MUA Submission: 2020-21

Planning and Forecasting Consultation on Inputs, Assumptions and Scenarios

1 February 2021

Australian Energy Market Operator

Figure 1: Renewable energy resources used to evaluate Renewable Energy Zones in the 2020 Integrated System Plan, and proposed to be used in the 2022 ISP. The left map is wind and the right is solar. Green indicates the best resources, weighted with other factors outlined in the ISP.

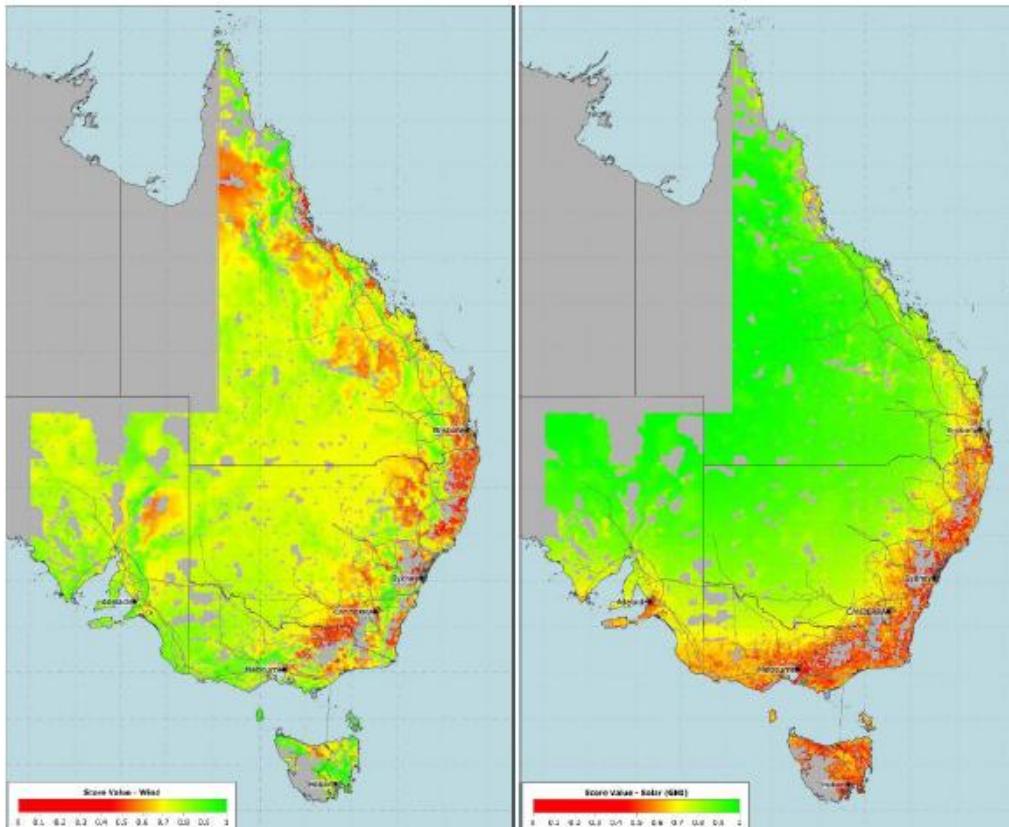
assessment⁵ of renewable energy resources and identification of Renewable Energy Zones that does not include offshore wind (p.108 of the Draft IASR Report).

As we previously raised in a letter to AEMO,⁶ the DNV report only looked at onshore renewable energy resources, and did not contain a justification of why. This may have been a reasonable (although short-sighted) approach in 2018, however, it now creates a risk that the 2022 ISP will be out of date and out of step with projects being planned and built in the NEM. A map of the renewable energy resources considered as part of the ISP is given in Figure 1. This should be compared with Figure 2, which shows the available wind resources in NSW (to give one example), including offshore wind.

We support AEMO's inclusion of offshore wind in the Gippsland REZ.⁷ However this is the only offshore wind location that has been included for the NEM (p.92). There is good reason for including offshore wind in Gippsland, but it is quite arbitrary to exclude the rest of the potential Australian coastal areas, and this seems out of step with the systematic way that the rest of the ISP is developed.

Recommendation: that AEMO must urgently update the available renewable energy resources used to map Renewable Energy Zones to include offshore renewable resources. The 2022 ISP process should no longer rely on the 2018 report by consultants DNV-GL that did not consider any offshore renewable resources, including offshore wind, ocean wave and tidal-current energy generation. The prioritisation and identification of Renewable Energy Zones for the 2022 ISP must be revised on the basis of the new analysis that includes offshore resources, and properly identifies their different capacities.

Figure 2: NSW wind speed. Red indicates highest mean annual wind speed, and blue is lowest.

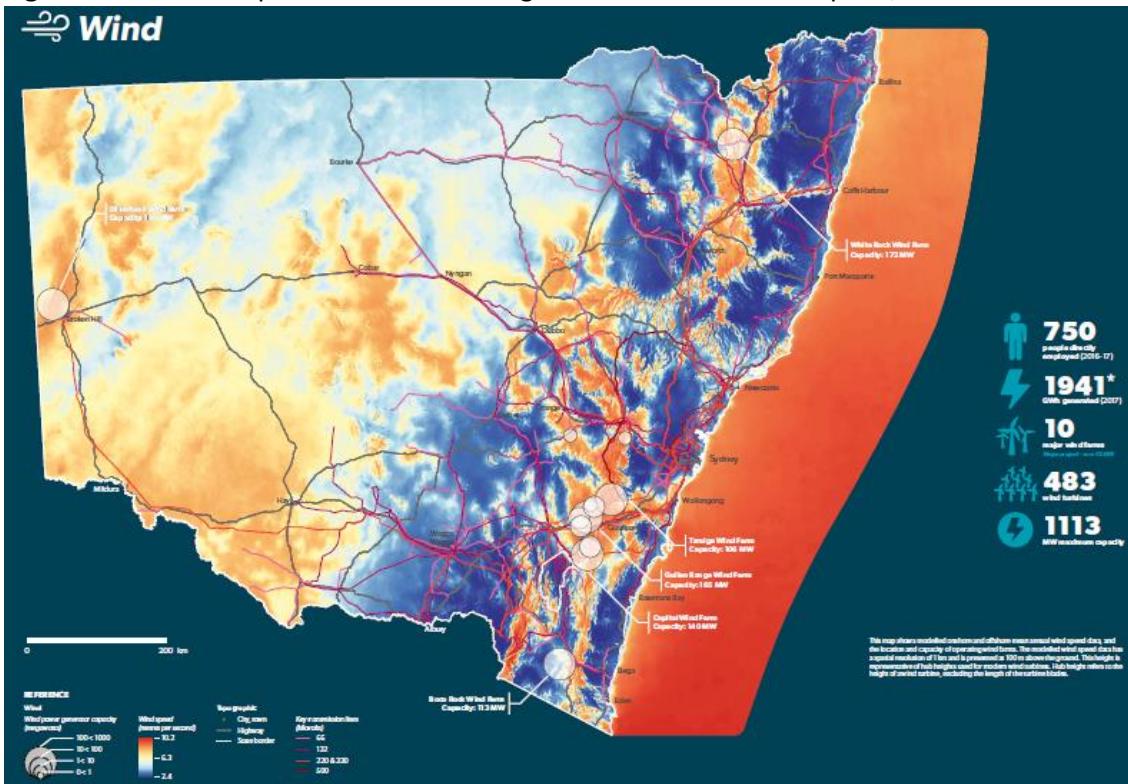
Without considering all the available renewable resources, we cannot be sure that the ISP's recommendations are the best possible plan. More consistent wind offshore with a high peak-demand contribution factor and high capacity factor could reduce the need for storage. Offshore wind has been described by the International Energy Agency (IEA) as having a 'value proposition potentially comparable to that of baseload technologies such as nuclear power and coal-fired generators.' The reliability and consistency of offshore wind 'reduces the need for investment in other dispatchable capacity, including investment in combined-cycle gas turbines (CCGTs).¹⁰
